Subject: AP1000 Response to Request for Additional Information (TR 54)

RAI-TR54-025 R1

# AP1000 TECHNICAL REPORT REVIEW

RAI Response Number: RAI-TR54-025  
Revision: 1

Figure 2-15: Loading Pattern for Run Number 5 - Mixed Loading Case

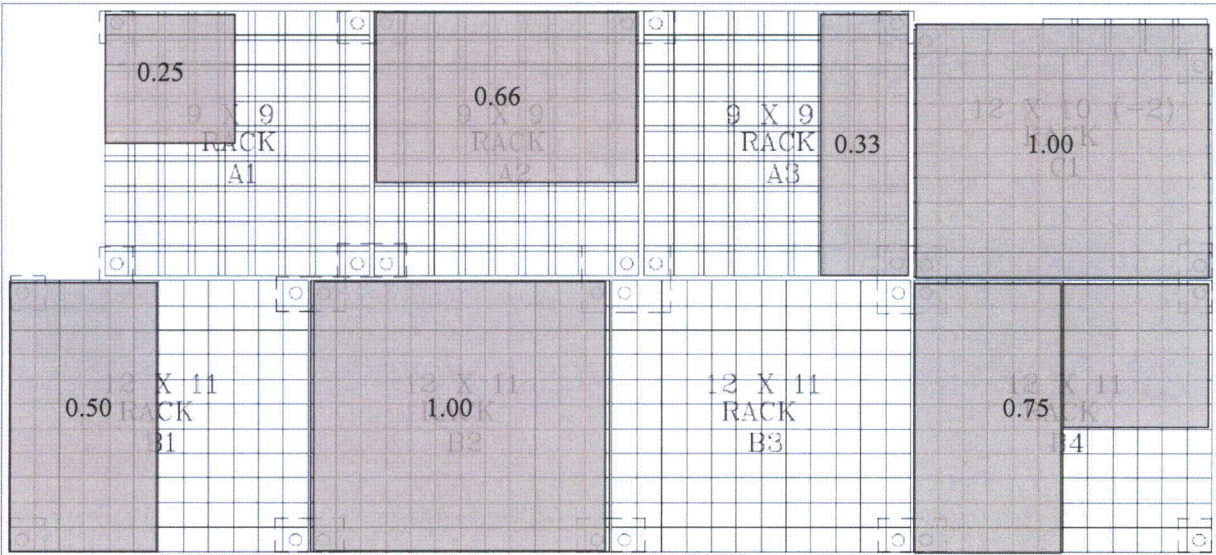
Explain whether only full fuel racks are included in the two simulations, or if several scenarios are considered; i. e., different fill ratios, from partially full to full within a given rack; varying fuel locations within the partially filled rack; varying fill and locations in adjacent racks. Provide the technical justification if only full racks are considered. Also, would it ever be possible to have less than all fuel racks (eight) in the pool. If so, then additional simulations would be needed. If not, is there a requirement in the DCD that specifies all fuel racks must always be in place whenever fuel is stored in any of the racks?

- Run number 4 considers increased rack to rack gaps (+0.5"). The gaps are modified in order to demonstrate the variation in results associated with the maximum acceptable rack to rack gaps.
- Run number 5 considers mixed fuel loading conditions as shown in Figure 2-15. The shaded boxes in Figure 2-15 represent the loading fraction and location where the assemblies were loaded in each rack; note, rack module B3 was modeled as empty for this run.
- Run number 6 considers decreasing the impact spring rates and rack beam stiffnesses by 20%.
- Run number 7 considers increasing the impact spring rates and rack beam stiffnesses by 20%. The purpose of run numbers 6 and 7 is to measure the sensitivity of the dynamic results to variations in the stiffness properties.

Figure 2-15 is added as follows:
